23-001

# Article 6 Site Plan Approval

**TOWN HALL  
 PROPOSED PARKING  
 LOT LAYOUT  
 Wayland, Massachusetts**

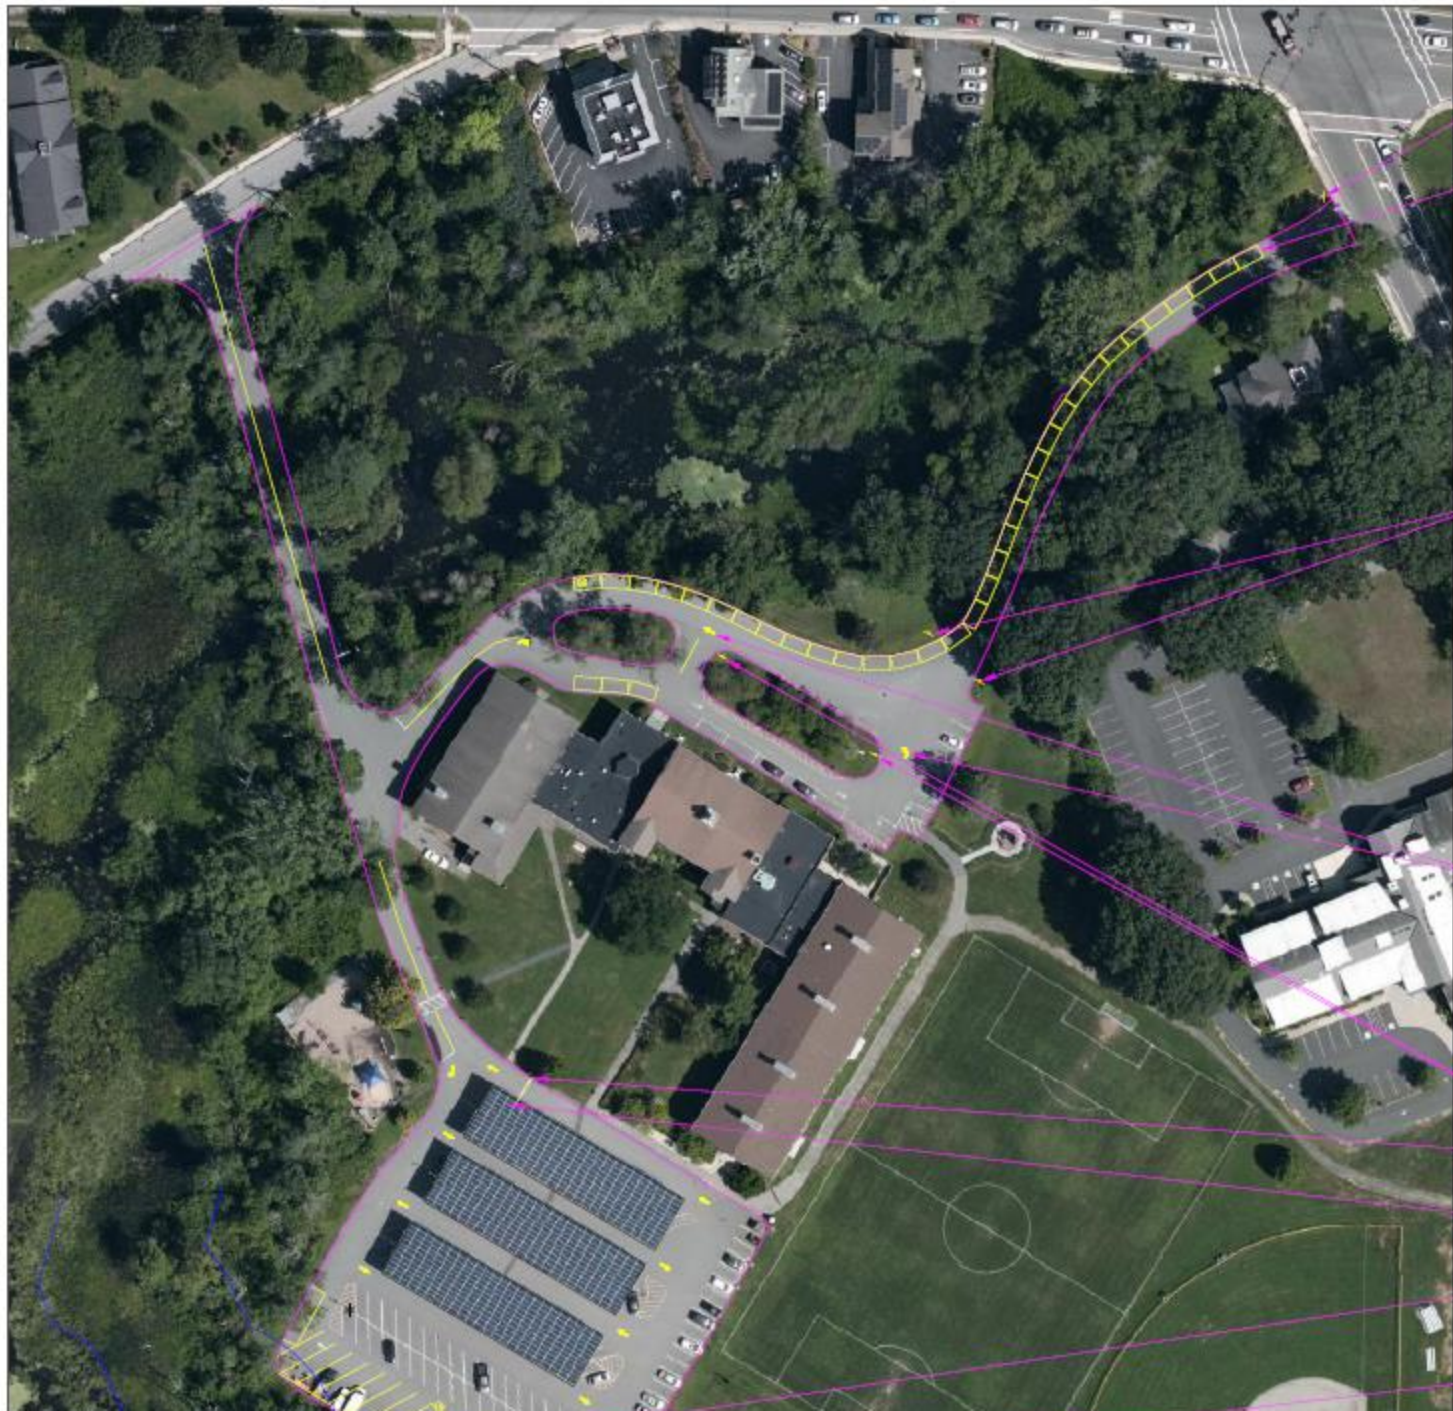
- The restriping and directional flow of parking does not meet the thresholds and criteria of the applicability to require Site Plan Approval (see section 601.2)
- **601.2.4.** For the purpose of this Article 6, "substantial alteration to areas of parking, loading or vehicular access" shall mean any proposal where all or part of such existing or proposed areas is located off the site of the primary use or structure; or where any resurfacing of such areas results in any change in the design of the septic or drainage systems on or for the site; or where any curb cut is relocated, added or otherwise changed; or where this Zoning Bylaw requires more parking than was required for the previous use;
